**Re: Comments for the Bureau of Ocean Energy and Management's Draft
Environmental Impact Statement for the Vineyard Wind Proposed Wind Energy
Facility, Docket Number BOEM-2018-0069**

ATTACHMENT A
National Marine Fisheries Service's Comments on
BOEM's Draft Environmental Impact Statement (DEIS) for the
Vineyard Wind Offshore Wind Energy Project (BOEM 2018-0069)

Figure 1: VMS fishing effort (0-5kts) for Atlantic Mackerel, Squid, and Butterfish trip declarations, 2010-2018. The Vineyard Wind Lease Area is outlined in red.

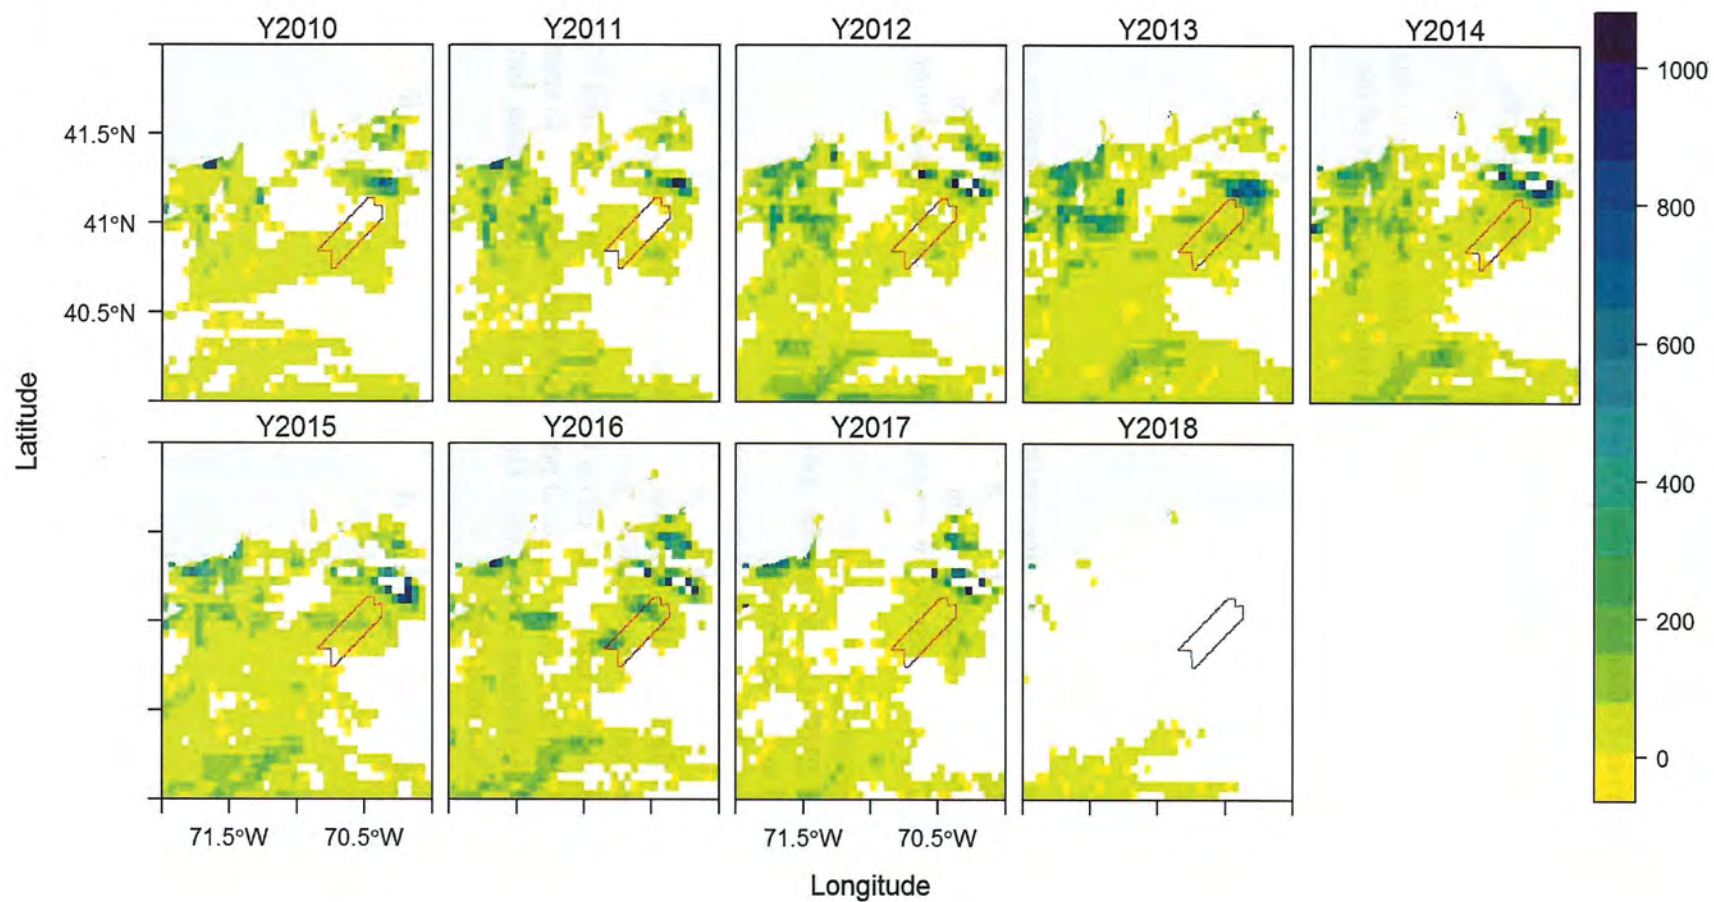
On page 3-163, the second paragraph states “Comparison of VMS data in 2015-2016 shows intensive use of the area for squid fishing (Figure 3.4.5-2). That is not an accurate description of the data. The data used for Figure 3.4.5-2 do not indicate squid fishing intensity, but rather the relative squid fishing vessel intensity during the year 2015-2016. VMS data show vessel presence, but do not indicate whether the vessel is fishing or not. This should be clearly indicated in the text, figure caption, and map legend. It has become a standard practice to “speed filter” VMS data so that maps better indicate likely fishing activity. Both speed-filtered and unfiltered VMS data are available from the Northeast Ocean Data portal for most fisheries. This figure should be created using the speed-filtered VMS data, which indicates vessels traveling at speeds less than four knots, which would more accurately depict squid fishing activity.

As noted previously for VMS data used in Figure 3.4.5-2, the maps in Figures 3.4.5-5 and 3.4.5-6 should include the explanation that the data represents fishing vessel intensity and not fishing activity or fishing revenue. These figures all should use data that is speed-filtered to show fishing vessel presence when vessels are travelling at less than 4 knots, which means they are more likely to be fishing. The maps look very different when built with speed-filtered data. If there is a reason the maps are using data that has not been filtered by speed, that point should be clearly noted in the text.
